ADDENDUM NO. 3

Project Name: **JACKIE ROBINSON TRAINING COMPLEX VILLAS REMODEL (IRC-1914A)**

Bid Number: **2022009**

This addendum is released to provide answers to questions received to date, and to replace pages from the Plan Set as noted in "Attachments".

SHEET NO.
A-5
OF SIX

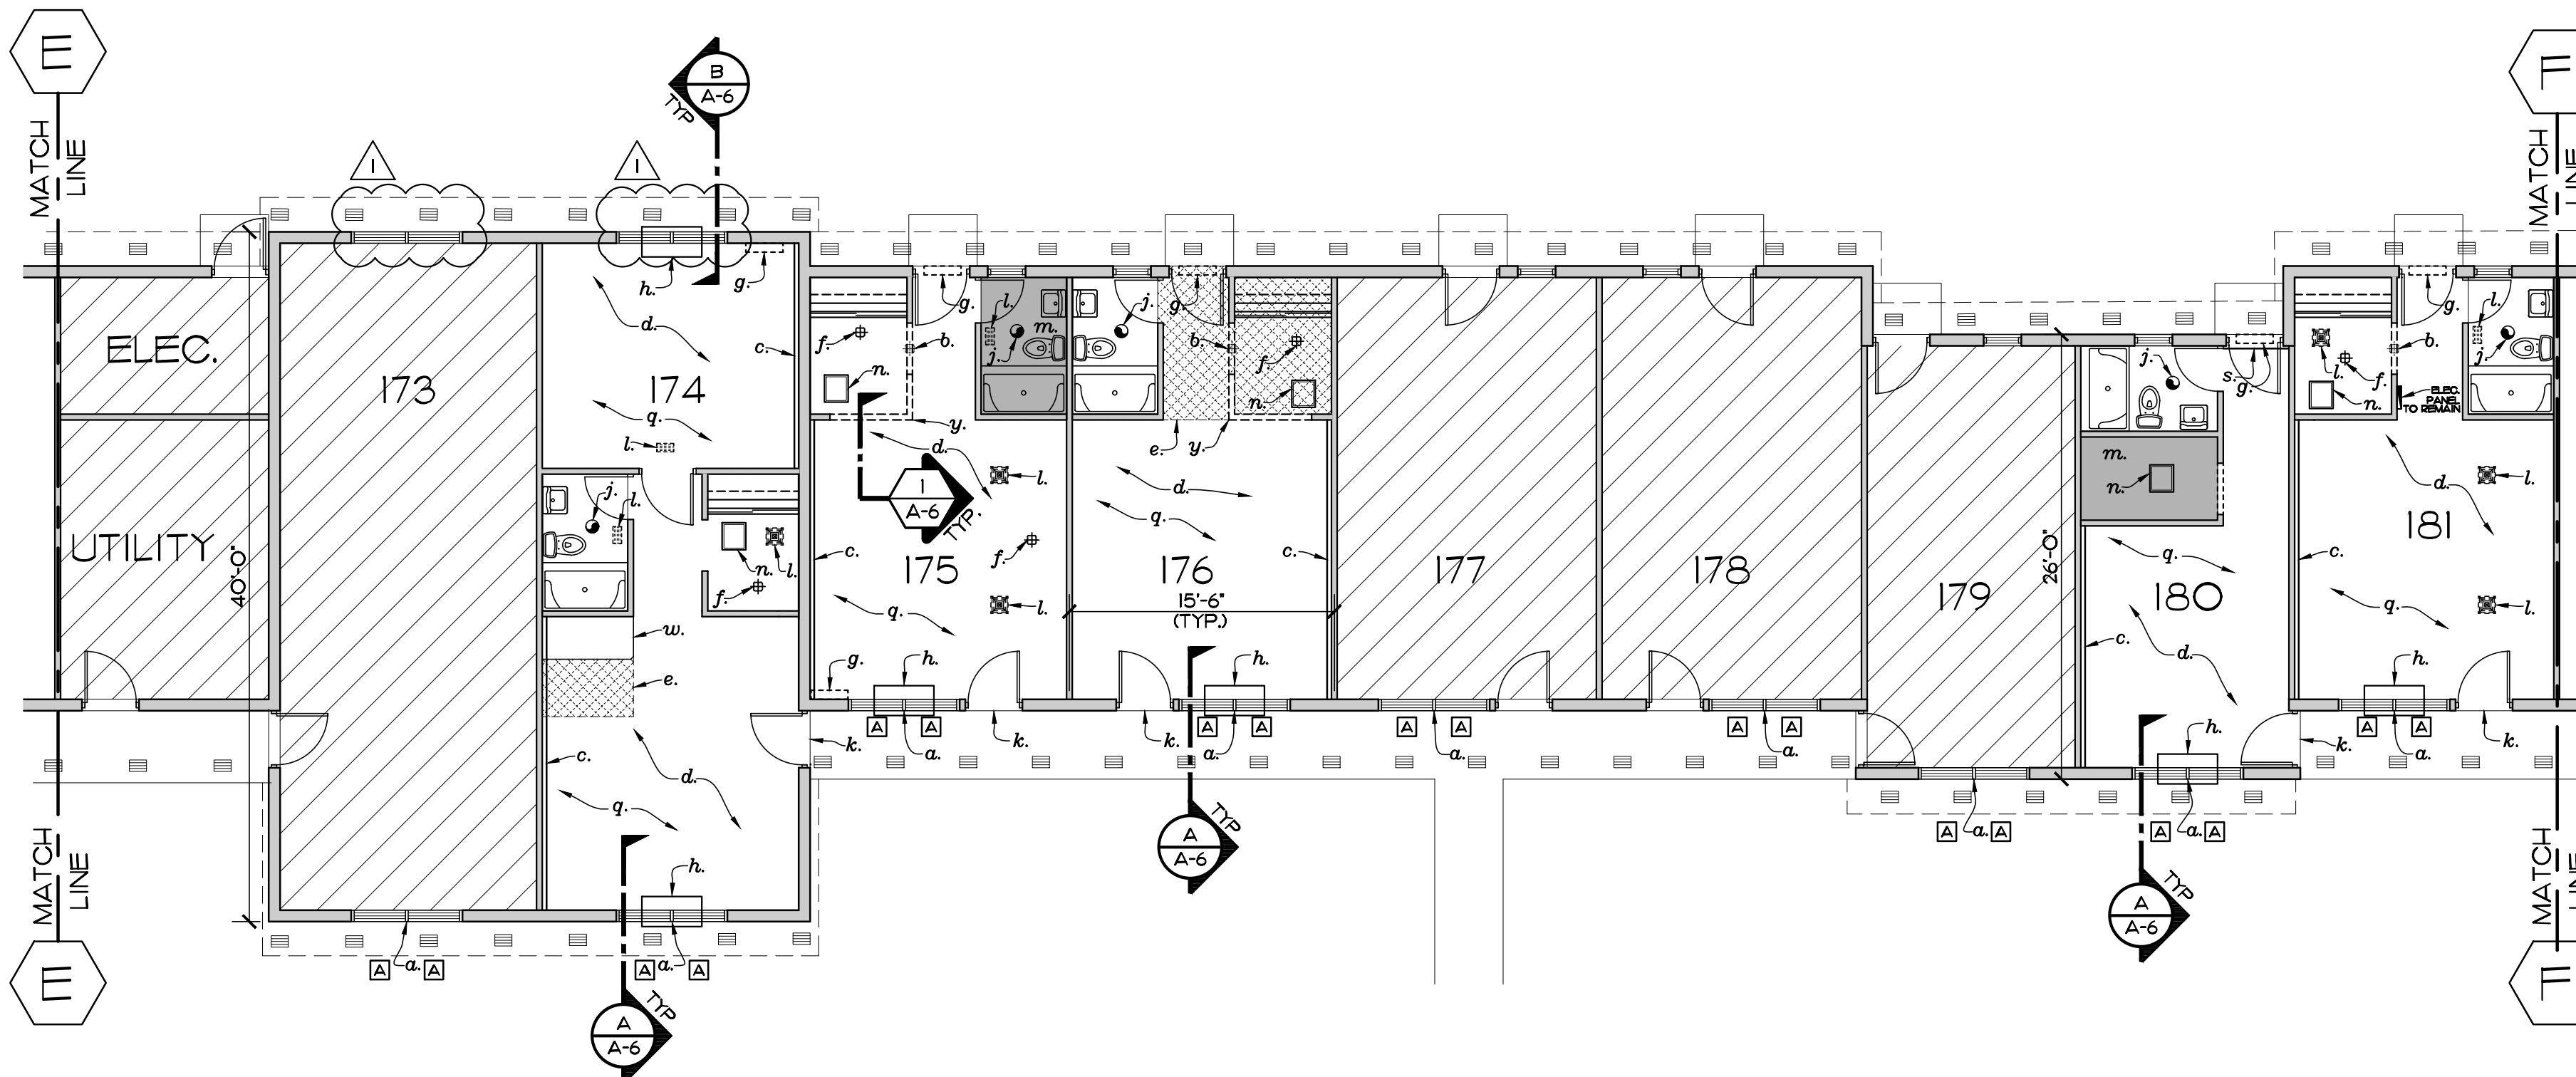
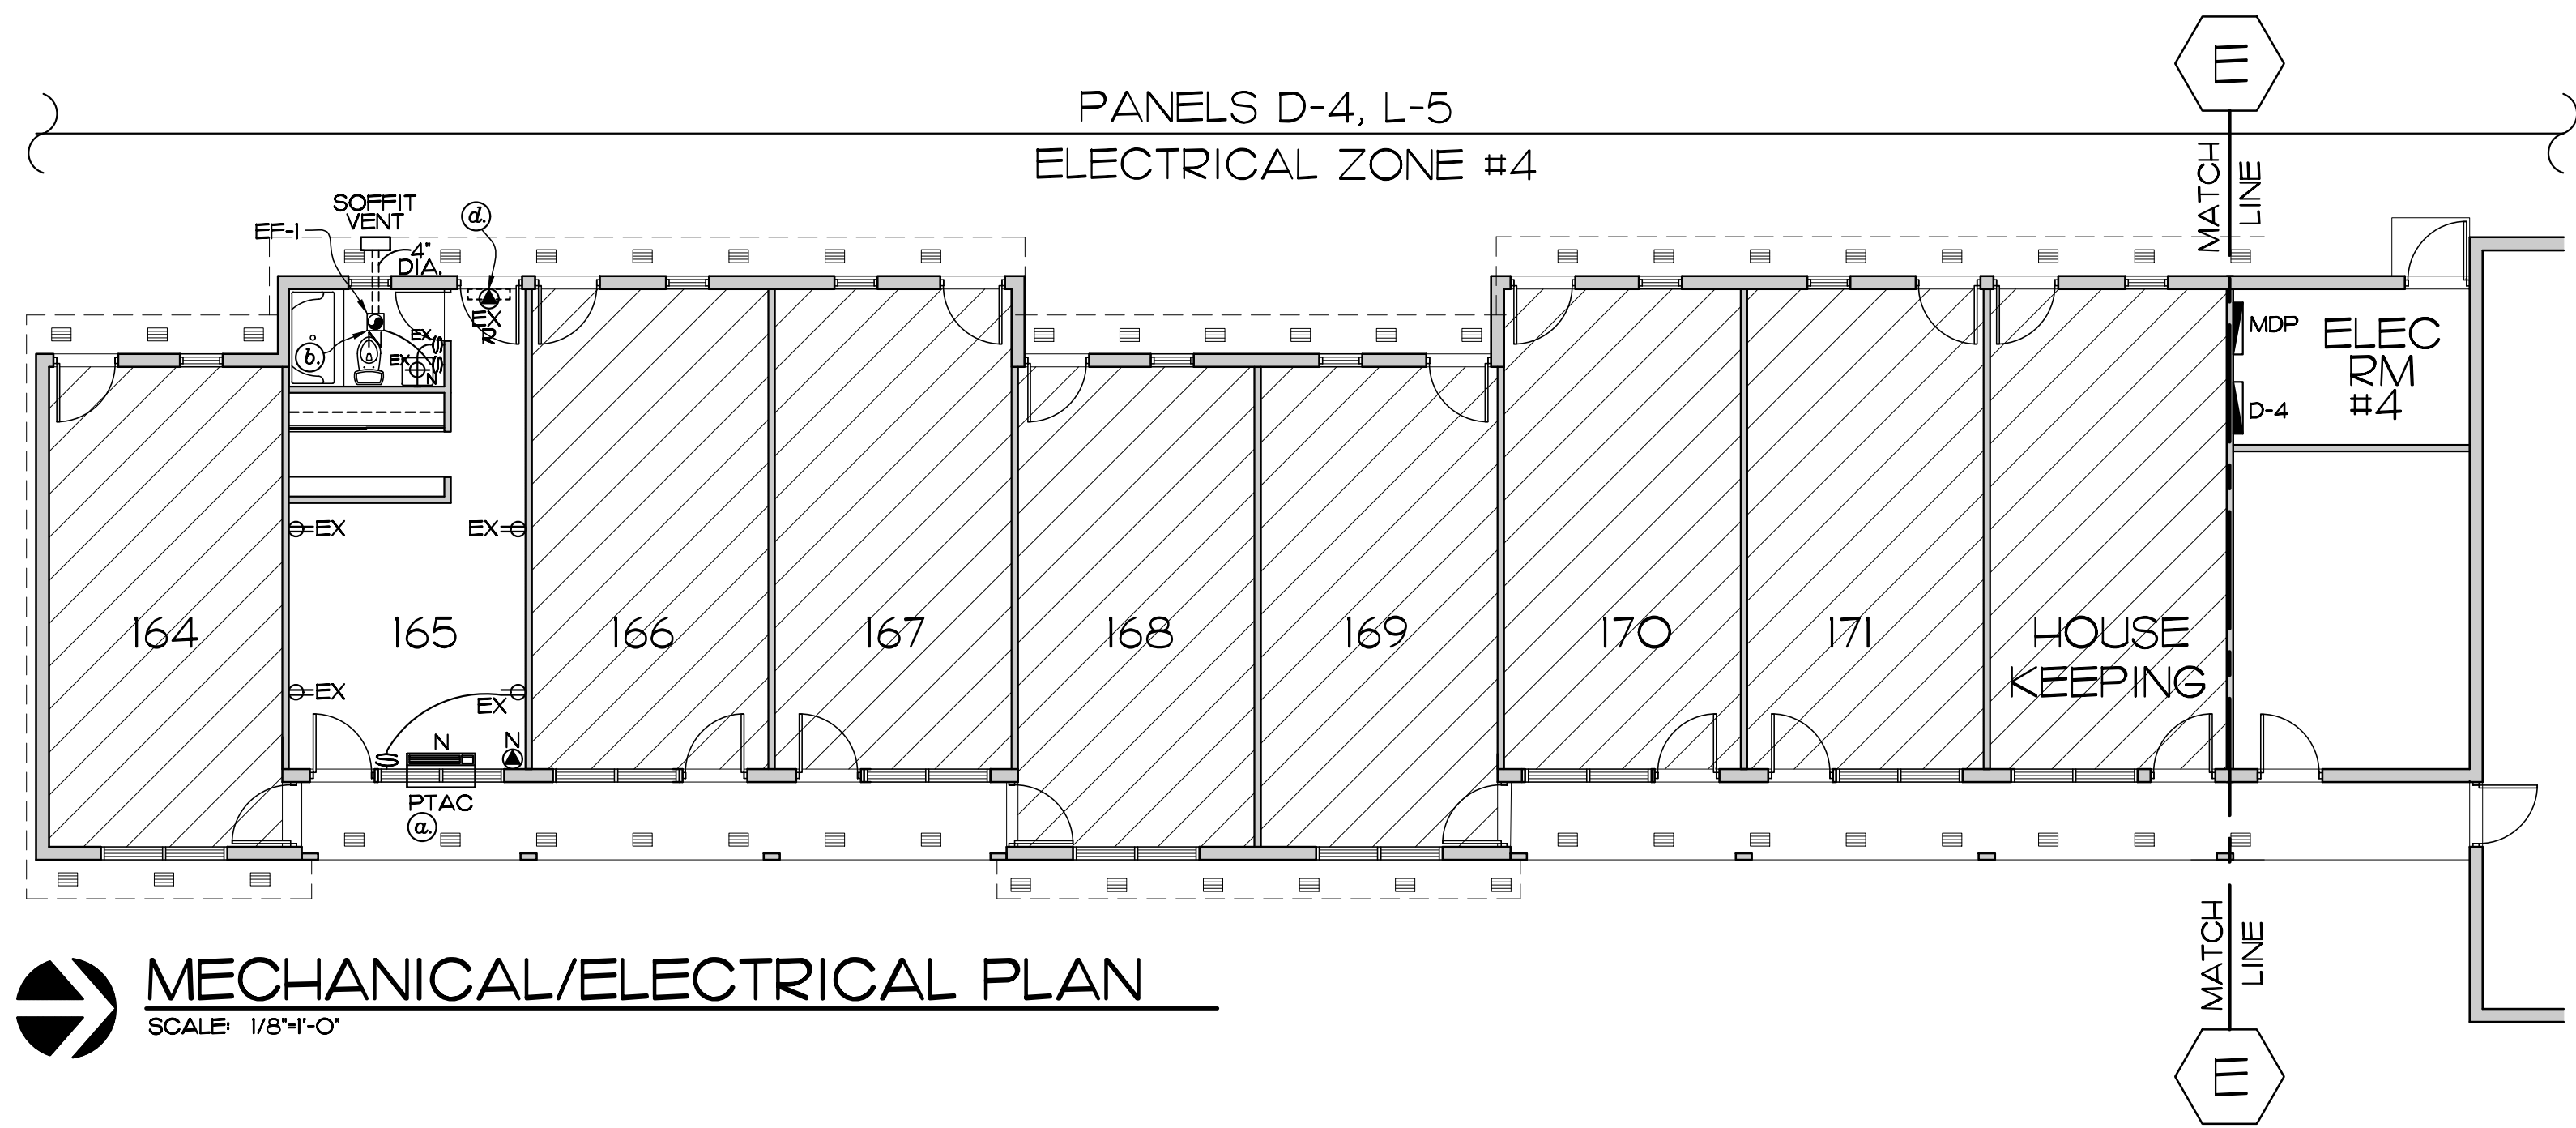
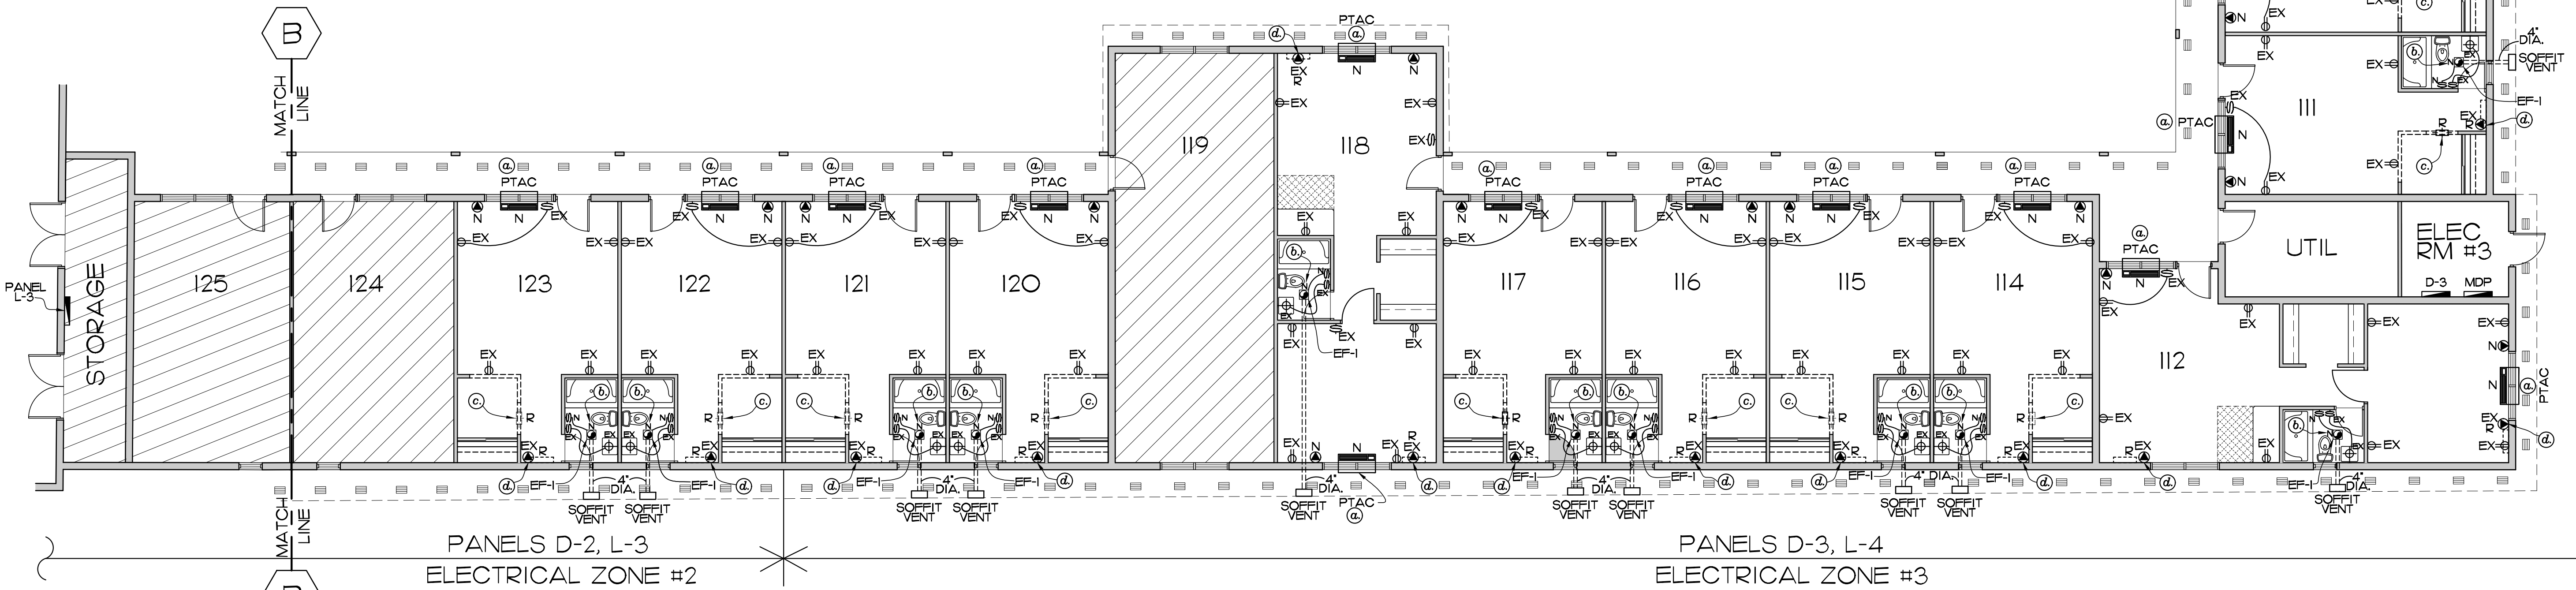
- Architectural plan sheets A-2 thru A-5: The bedroom windows in all of the suites are to remain. These were mis-labeled on plans to be replaced, therefore there will be no change in quantity.
- Sheet A-2 - Additional "r" call-outs have been added to room 107.
- Sheet A-4 – Shading has been added to Kitchen ceilings in rooms 150, 151, 153, and 154. Shading was also added to living room ceiling in room 161.
- Mechanical/Electrical Plans M-1 thru M-4; Trane PTAC unit specified in A/C Equipment schedule is no longer available and has been replaced with a GE PTAC unit, associated electrical notes have been revised.
- Itemized Bid Schedule; Item 1 expanded the description of Mobilization.
- Appendix C - Asbestos Survey Report: Page 4 of report under Drywall System (Texture) the word friable has been replaced with non-friable.
